- 3. Patson Properties Cude Addition; KPB File 2023-101
McLane Consulting Group / SBC 2012 Family Trust
Location: Patson Road PINs: 13524330, 31 & 32
Funny River Area / Funny River APC**

**ITEM #3 - PRELIMINARY PLAT
PATSON PROPERTIES CUDE ADDITION**

STAFF REPORT

PATSON PROPERTIES CUBE ADDITION
 A RESUBDIVISION OF LOT 1, LOT 2 & TRACT A2 PATSON PROPERTIES
 A/SUBDIVISION ADDITION KN2020-47

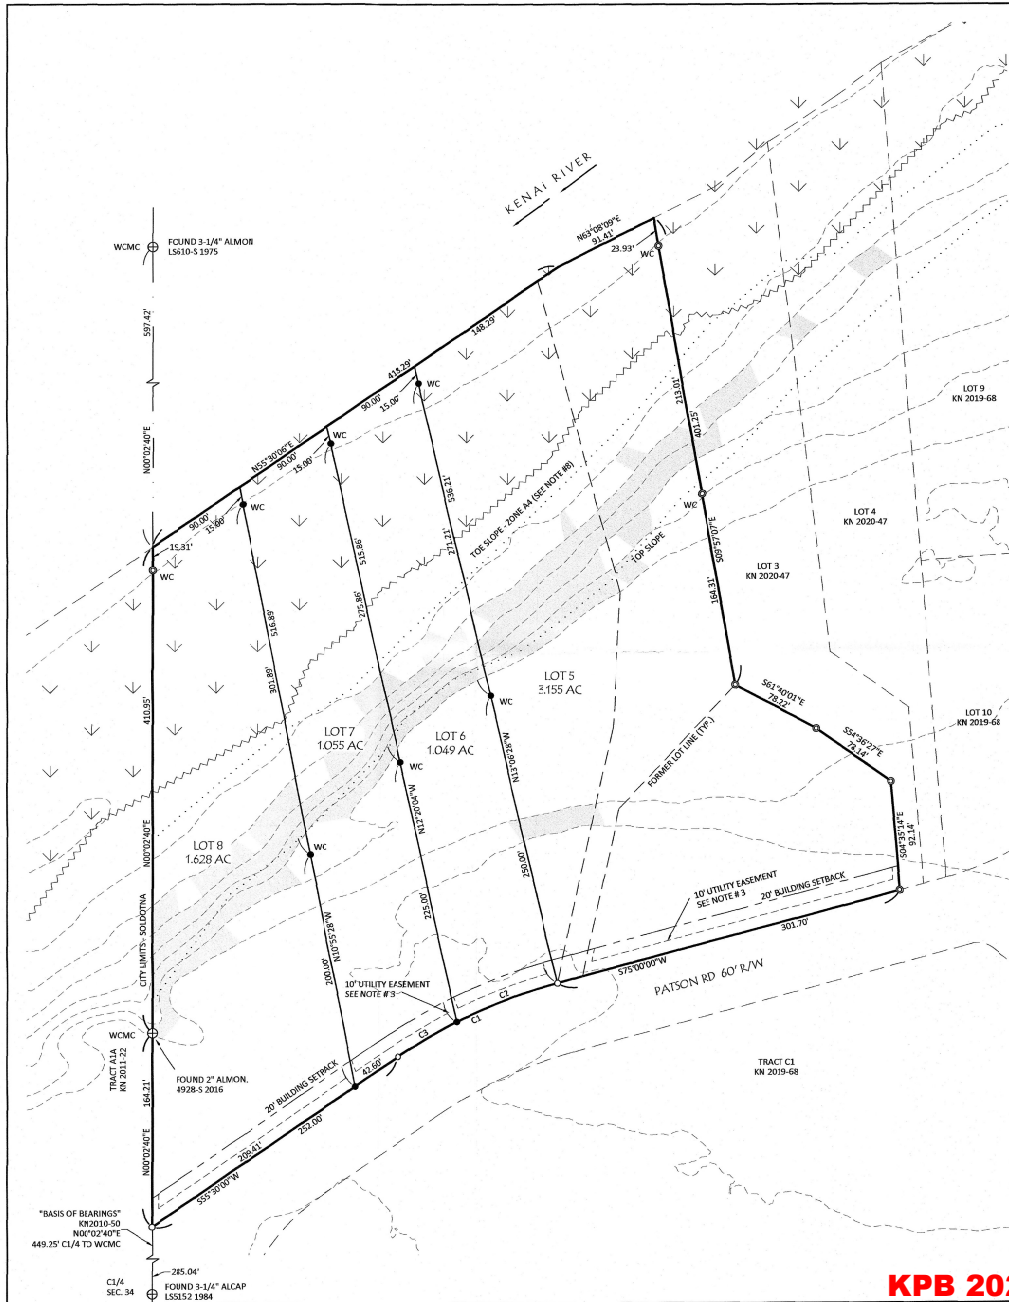
Site Investigation: This subdivision is located along the Kenai River and has steep slopes over 20 percent that are shown on the plat. ***Staff recommends: the areas with 20 percent or more grade remain on the final plat.***

There is an existing structure that will be entirely within proposed lot eight. There does not appear to be any encroachments. There appears to be a paved pathway from the structure running easterly through the proposed lots. If this pathway is to remain in use, an easement agreement should be filed between lots as ownership changes.

Utility Easements Ten-foot utility easements have been granted along Patson Road. The former flag of the lots depicted the entire setback within five feet of the side lot lines also a utility easement and is currently not shown. **Staff recommends:** *updating the depiction to reflect the utility easement of the new configuration.*

Staff recommendation: Correct the name of the owner to SBC 2012 Family Trust.
Add Suite B to the owner's address.

Platting Staff Comments: soils report will be required.

The boundaries of proposed lots 5 through 8 exceed the 3:1 depth to width requirement. When calculating the 3:1 depth to width ratio following the usable area limits,
